APPLICATION NO.	FILING DATE	FIRST NAMED INVENTOR	ATTORNEY DOCKET NO.	CONFIRMATION NO.
10/529,597	12/29/2005	Jyrki Kauppinen	028443-071	1736

Office Action Summary	Application No. 10/529,597	Applicant(s) KAUPPINEN, JYRKI	
	Examiner Jonathon D. Cook	Art Unit 2886

Detailed Action

(Modified figure 2)

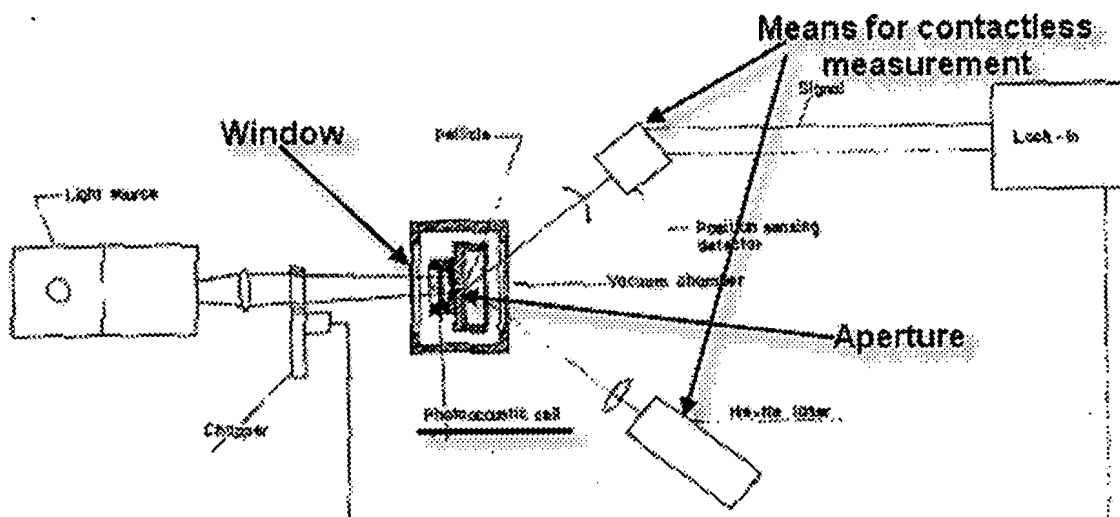
Regarding **Claim 16**, de Paula discloses and shows in **fig. 2** a microphone for photoacoustics, comprising:

a photoacoustic cell (applicant's first chamber) suppliable with a gas to be analyzed;

a window for letting modulated and/or pulsed infrared radiation and/or light in the first chamber (see modified figure 2);

a means for detecting pressure variations created in the first chamber by the absorbed infrared radiation and/or light, where the means for detecting pressure

variations created in the first chamber by absorbed infrared radiation and/or light, comprise:

an duct (applicant's aperture) provided in the wall of the first chamber, in communication with which is provided a pellicle (applicant's door) adapted to be movable in response to movement of a gas (see modified figure 2);

a means for contactless measurement of the door movement (see modified figure 2);

Regarding **Claims 20 & 21**, de Paula discloses and shows in **fig. 2** the means for a contactless measurement comprises an optical measuring system, comprising:

an He-Ne laser (applicant's one or more light source) for illuminating the door as a part thereof; and

a position sensing detector (applicant's one or more detectors) for receiving light reflected from the door and for measuring the door movement as an optical angular and/or translatory measurement.

(Modified figure 4)

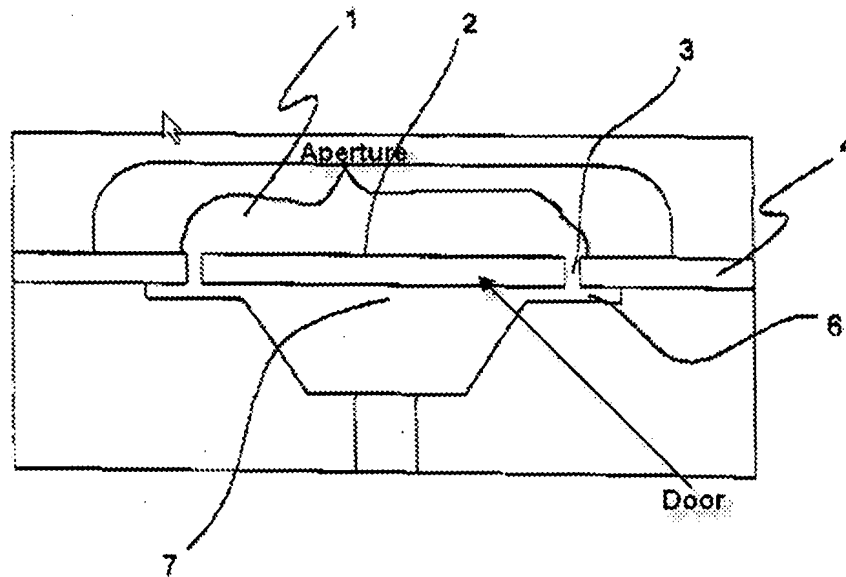
However, Meringdal teaches and shows in **fig. 4** a sensor diaphragm (2) which is slightly smaller than the aperture (see Modified figure 4).

Therefore, it would at least been obvious to one of ordinary skill in the art at the time the invention was made to modify the invention of de Paula with the door has a surface area which is at most equal to the surface area of the aperture because it will allow for freedom of movement of the door, which will not be brushing against the side of the aperture, and therefore provide better sensitivity to vibratory impulses due to pressure shifts.
